HARTZELL PROPELLER INC.
ALERT SERVICE BULLETIN
TRANSMITTAL SHEET
HC-ASB-61-313
Propeller - Counterweight Slug Bolt Inspection

July 15, 2009

This page transmits a revision to Alert Service Bulletin HC-ASB-61-313.

This revision is issued to change the following in the Alert Service Bulletin:

Counterweight Slug Attachment Bolt Identification
Figure 1

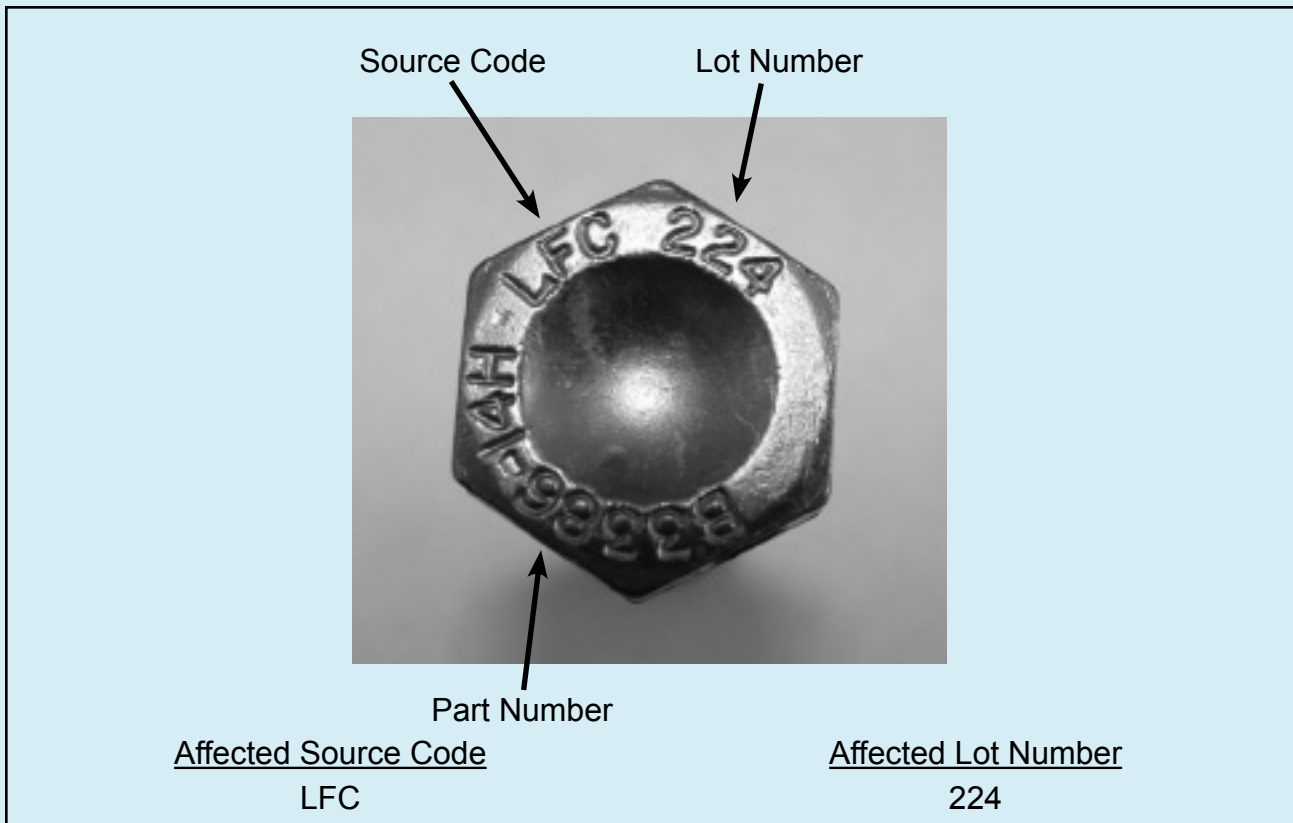
- (a) Locate the counterweight slug attachment bolts. Refer to Figure 2.
- (b) Inspect each B-3386-14H counterweight slug attachment bolt on the propeller for the affected LFC manufacturing lot. Refer to Figure 1.
 - 1 Bolts marked from another source code or lot number other than 224 are not affected by this Alert Service Bulletin.
 - 2 If only one counterweight slug attachment bolt on a counterweight slug is from the affected LFC manufacturing lot 224, both bolts may require replacement.
 - 3 Visually inspect all LFC manufacturing lot 224 counterweight slug attachment bolts for the following obvious signs of failure:

- (1) Inspect each B-3386-14H counterweight slug attachment bolt for the affected LFC manufacturing lot number. See Figure 1.
 - (a) Bolts marked from another source code or lot number other than 224 are not affected by this Alert Service Bulletin.
- (2) Immediately quarantine all affected bolts.

Figure 2

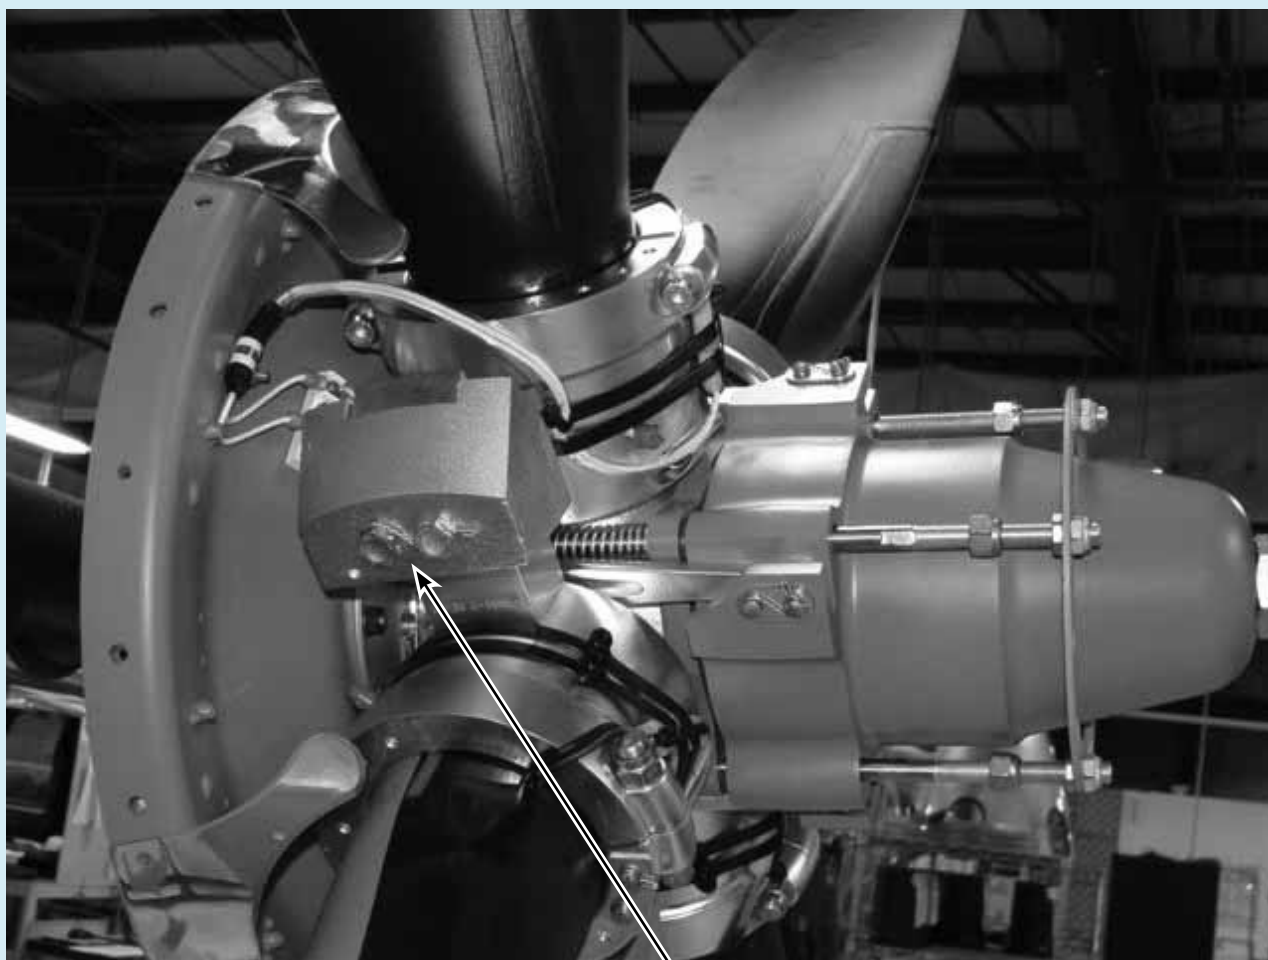
- Clarify that applications that have previously complied with an earlier version of this Alert Service Bulletin are not affected by this revision.
- Add HC-B4TN-5QL as an affected propeller in Table 1.
- Add reference and alternate method of compliance for FAA AD 2009-10-14.
- Modify compliance time to start from date of original issue instead of date of receipt.
- Clarify that one-time compliance is terminating action.
- Add Figure 2 to clarify location of affected bolts.

Inspect B-3386-14H bolts in this location
on each blade (two bolts per blade)
